REPORT FOR ACTION

5, 7 and 9 Dale Avenue Official Plan and Zoning Amendment Applications Request for Direction - Supplementary Report

Date: July 25, 2018
 To: City Council
 From: Chief Planner and Executive Director, City Planning
 Wards: Ward 27 – Toronto Centre-Rosedale

Attachment 2: Revised Proposal - Site Plan with Modifications Highlighted

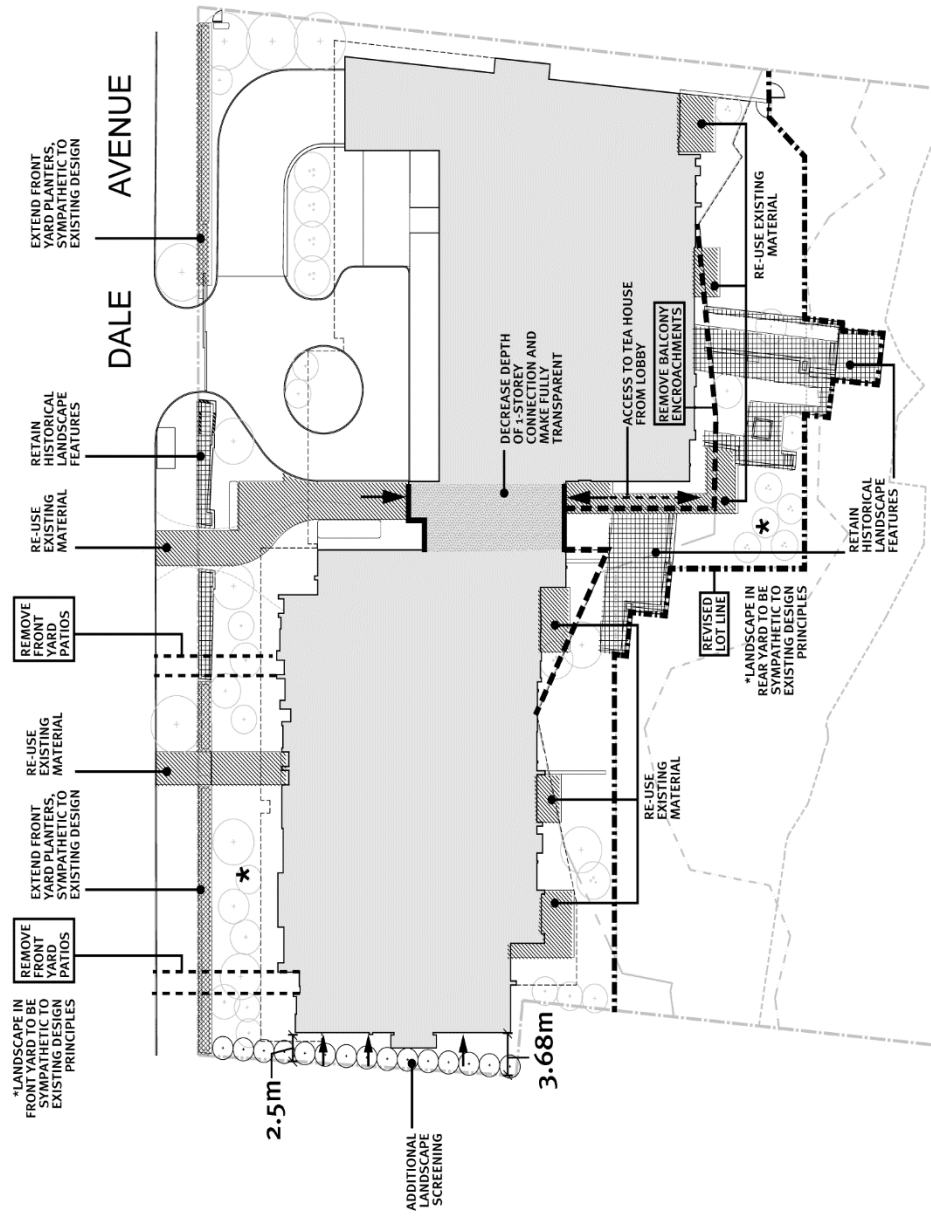
- Retaining the "tea house", planting beds and garden walls, and as much of the historic landscape and landscaping features as possible in the rear yard of 7 Dale Avenue to be used as a common outdoor amenity space, subject to the approval of TRCA and RNFP staff. Planning staff have begun discussions with the TRCA regarding these modifications;

- Retaining as much of the historic landscape and landscaping features at the front of the property as possible, such as the front yard boundary wall-planter, iron railings and gates;

- Extending the front yard planters in a form that does not replicate but responds sympathetically to the existing planters;
- Removing front yard outdoor patios and two pedestrian walkways to increase the amount of soft yard landscaping;

- Landscaping the new front and rear yards in a form that is sympathetic to the design principles of the existing landscaping;
- Reusing existing paving materials for the front entrance walkway, the emergency walkway from the west half of the building, and rear terraces;

- Increasing the west side yard setback for the front portion of the building to a minimum of 2.5 metres to allow sufficient space for 6 inch caliper, 25 foot tall beech trees to be planted along the west side wall;

- Continuing the west side yard beech trees into the front yard to further screen the building from the public realm;
- Removing balcony encroachments into the 3.6-metre gap between the two halves of the building to increase visual permeability into the ravine; and

- Decreasing the depth of the 1-storey portion of the building connecting the two halves of the building and making the north and south walls fully transparent to further enhance the visual permeability into the ravine.

The with prejudice settlement offer responds to the concerns raised by HPS and satisfies the guidelines regarding the demolition of the three Category "C" buildings.

The with prejudice settlement offer responds to the concerns raised by conserving elements of the heritage landscape and modifying the building to increase the amount of soft landscaping on the site and views through the two wings of the building.
